LINCOLN CITY/LANCASTER COUNTY PLANNING STAFF REPORT

P.A.S.: Use Permit #133
Change of Zone #3253
Change of Zone #3195

DATE: ~~November 13, 2001~~
Revised 11/29/01

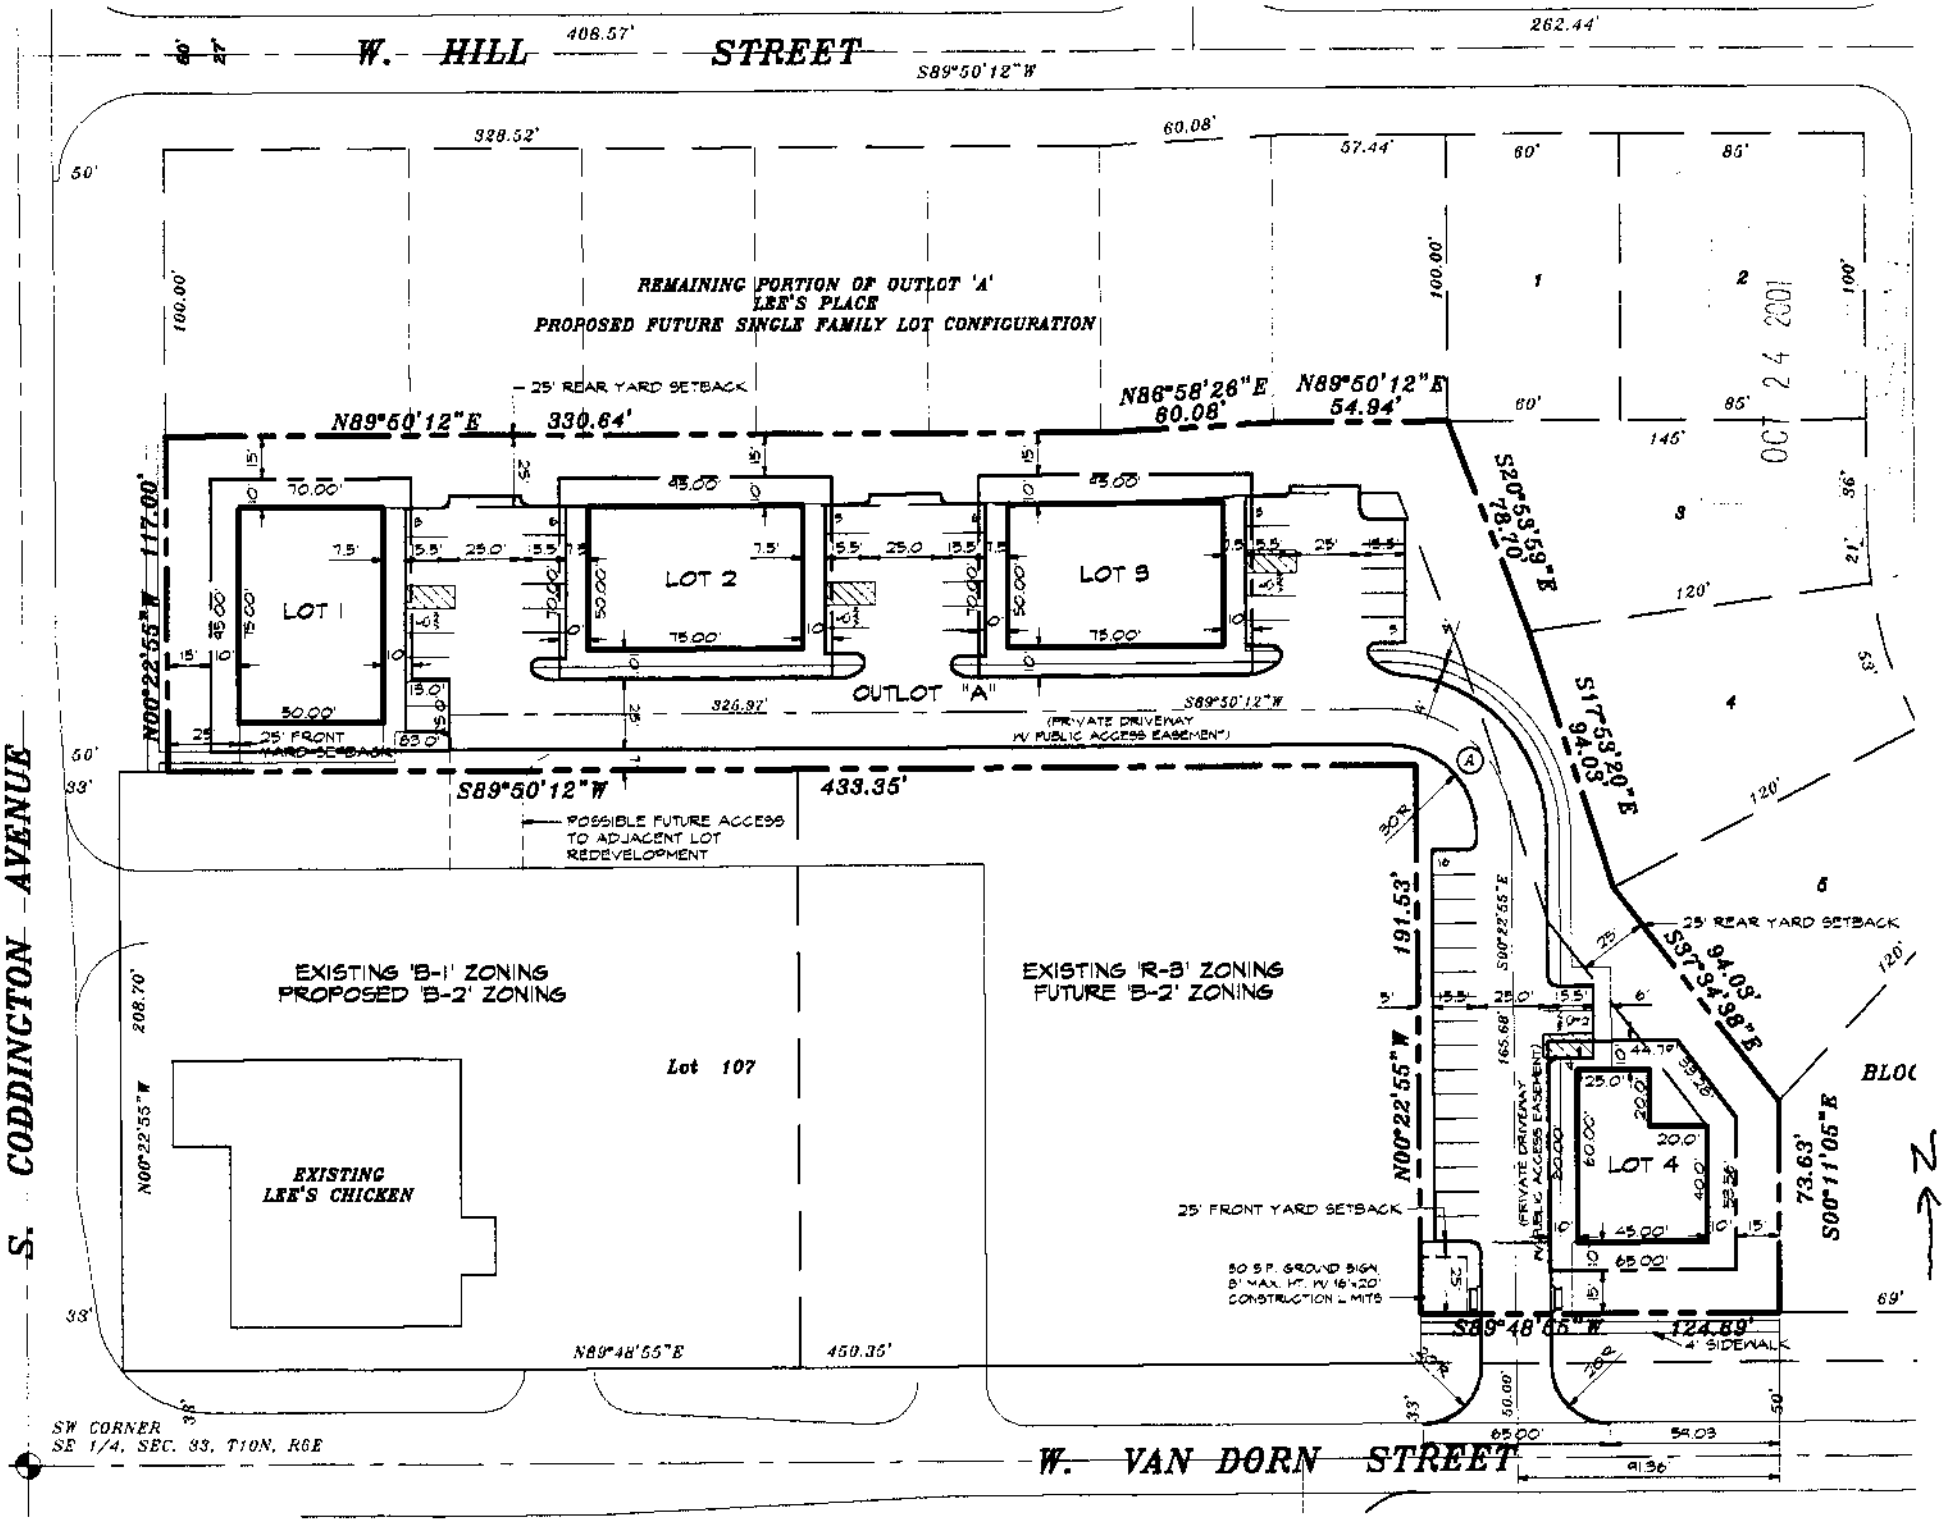
1.1 Revise the North site plan to show:

1.1.1 Add a note stating “A change from office to another commercial use shall require a public hearing.”

1.1.2 Label the building envelopes.

1.1.3 Label the lot lines.

1.1.5 Delete waiver request number 3.

1.1.6 Label the purpose of Outlot A.

1.1.7 Provide landscaping which meets Design Standards.

1.1.8 Correct the planting size for Skyline Honeylocust and Amur Maple - they should be 1-1/2 inches in diameter.

LANDSCAPE PLAN

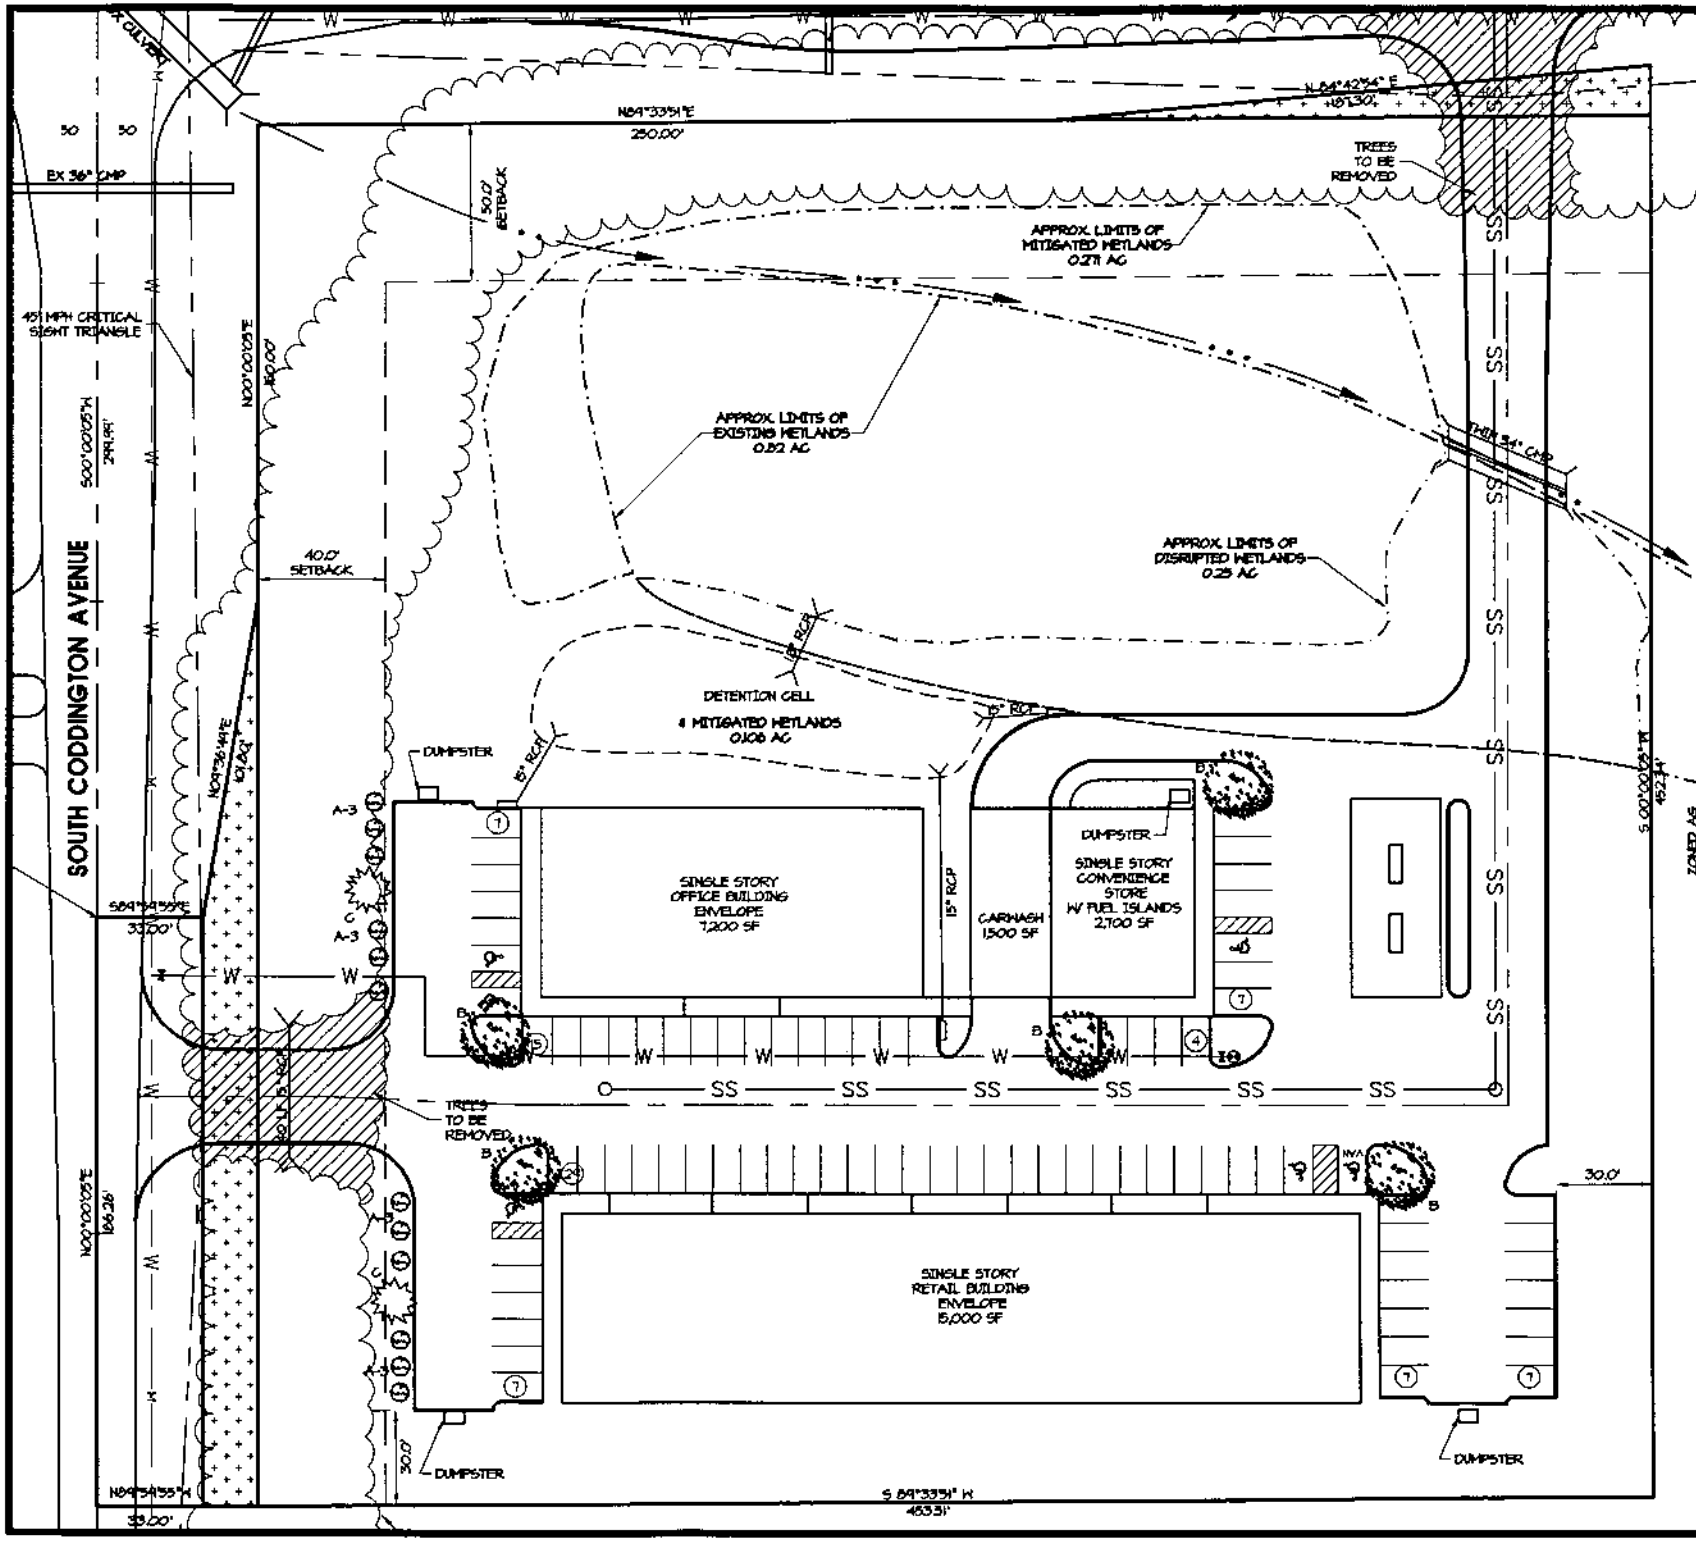
1.2.1 A planting plan for the detention cell as requested by Parks & Recreation.

1.2.8 Substitute Austrian Pine for White Fir. Austrian Pine has historical significance in this corridor.

Resubmit a Landscape Plan with the following changes:

1. Existing tree mass including Austrian Pines and Lilacs have historical significance along this corridor. Plant material should be recognized and be reflected in the long term planning and planting plans.

2. Provide planting plan on detention cell to help determine the water quality taking into consideration the parking lot runoff will contain petrochemicals. A pre-treated area or cell should occur before runoff enters wetlands.

3. The Comprehensive Plan indicates trail connection along frontage of property. Need trail easement location along Coddington with a 10' wide concrete trail, either through on the east side of the existing tree mass.
